WATTS BAR NUCLEAR PLANT (WBN) UNITS 1 AND 2 - REQUEST FOR ADDITIONAL
INFORMATION ON FSAR CHAPTER 3 AS REVISED BY AMENDMENT 79 (TAC NOS. M88488
AND M88489)

This letter provides TVA's response to the NRC's request for additional
information (RAI) dated October 11, 1994, concerning the subject FSAR
chapter for WBN.

WATTS BAR NUCLEAR PLANT UNITS 1 AND 2 FINAL SAFETY ANALYSIS REPORT (FSAR), CHAPTER 3 REQUEST FOR ADDITIONAL INFORMATION (RAI) RESPONSE

**Fig. 4.2.6
UNIT-1 RCP TIE ROD AND RPV
SUPPORT ARRANGEMENT - CASE 1**

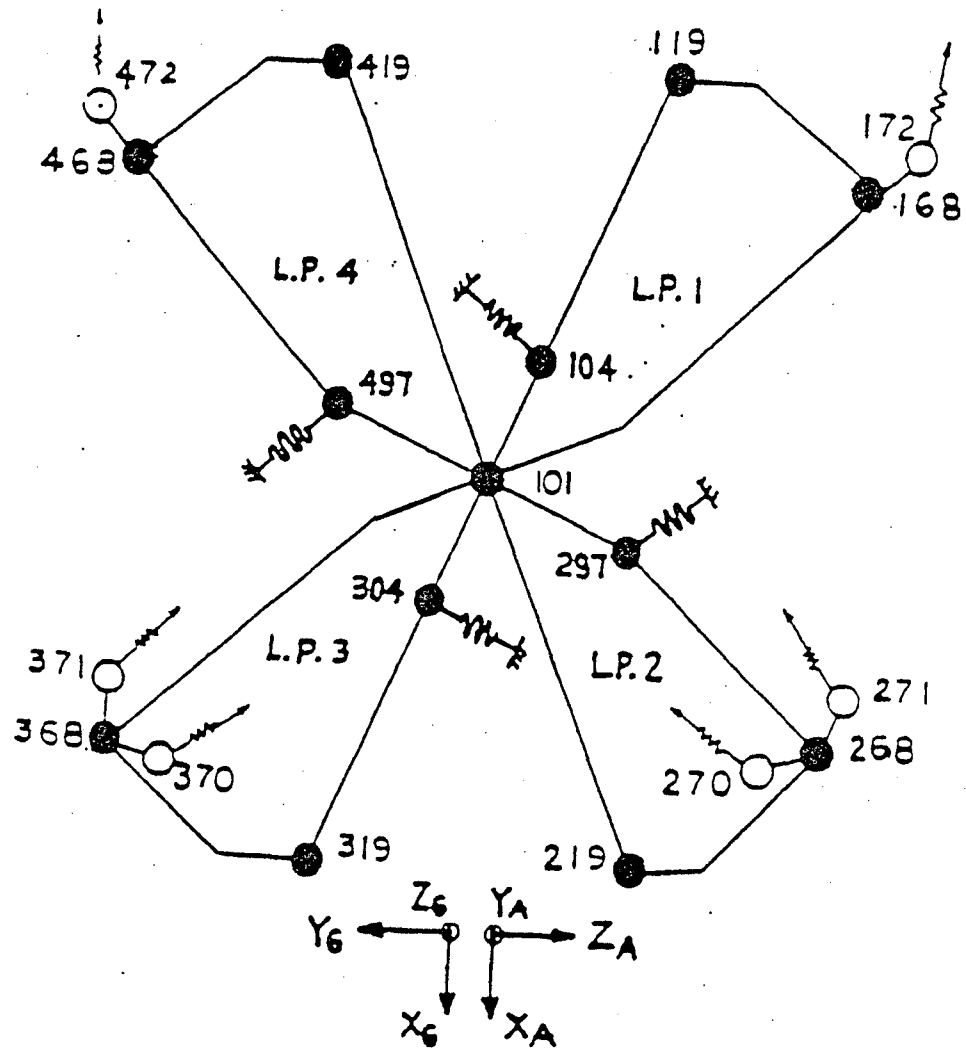
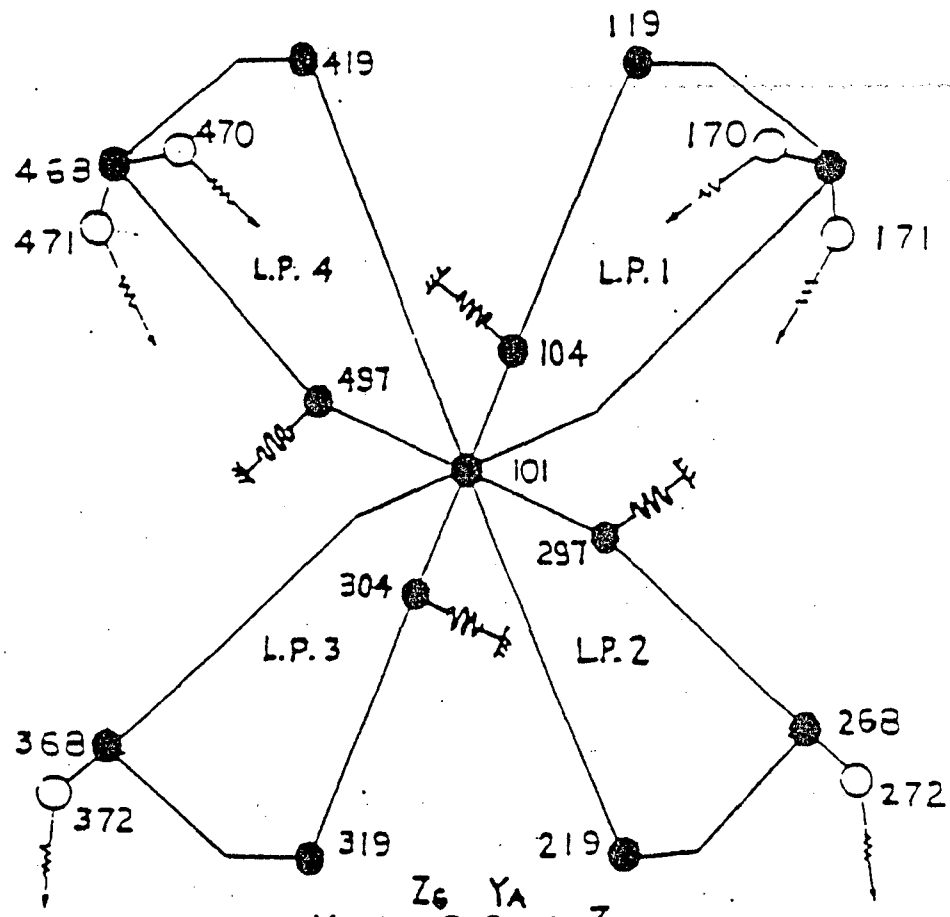
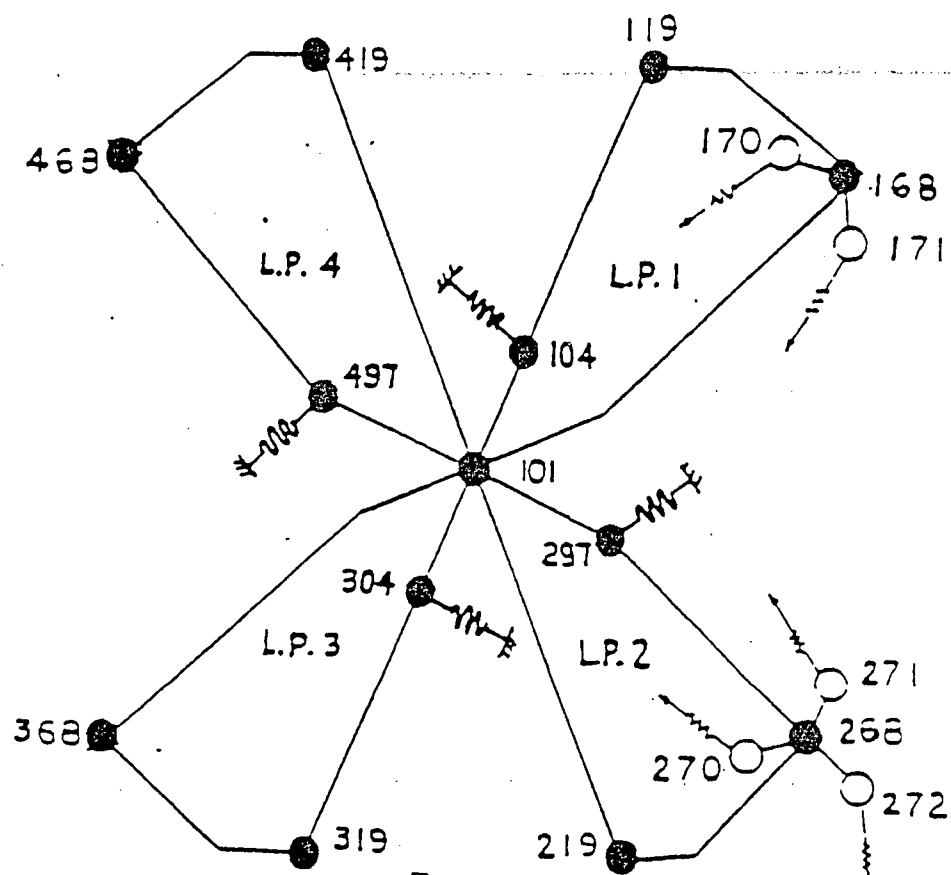
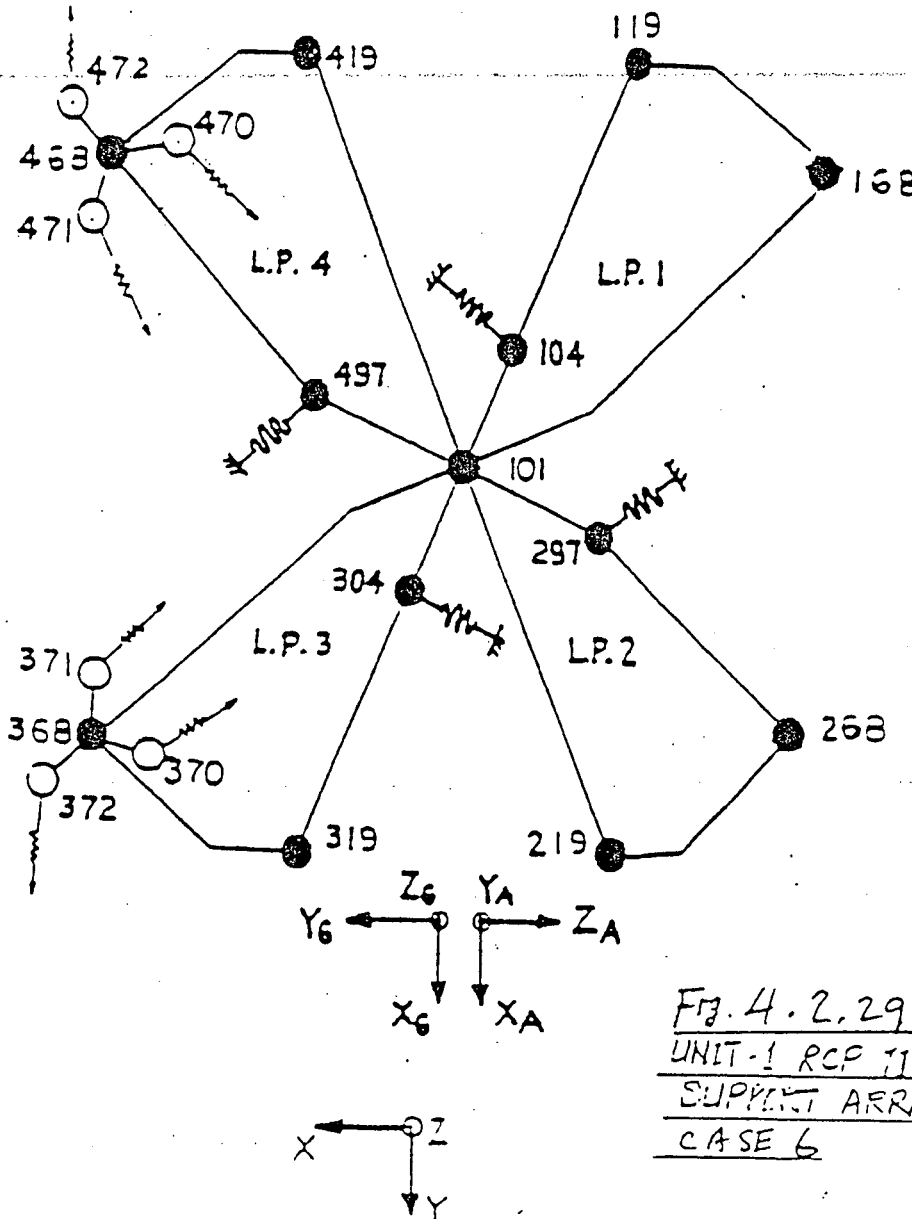
1. Geometry and sketches of the model,
2. Engineering data, such as, mass, spring, damping, size and location of the gaps, location of one-way hangers,
3. Description of modelling of gap and one-way hanger and validation of such model,
4. Detailed description of four linearized NSSS support stiffness and a discussion of how such supports adequately represent the nonlinear system being evaluated,
5. Discussion of governing equation of motion and the validation of numerical integration algorithm including stability and error estimate as discussed in "Analysis of Numerical Methods," E. Isaacson and H. B. Keller, 1966 .
6. Validation of overall model and
7. Summary of the calculated stresses of the critical members both in concrete structure and piping and supports, corresponding allowable stresses and references from which the allowable stresses are quoted."

Three tie rods are provided for each RCP (See Attachment 1 for FSAR Figure 5.5-8). These tie rods are assumed to function in tension only. Therefore, for postulated earthquake motion in each direction, the tie rods are assumed to be ineffective in compression. Eventually, the lateral resistance of the tie-rod assemblage is provided by that portion of the assemblage that experiences tensile loads. Figures 7 thru 10 in Attachment 2 of this enclosure show the active tie rods for Cases 1, 3, 5, and 6. The stiffness of the tie rod is provided by Westinghouse by a set of 6 x 6 generalized support stiffness matrix.
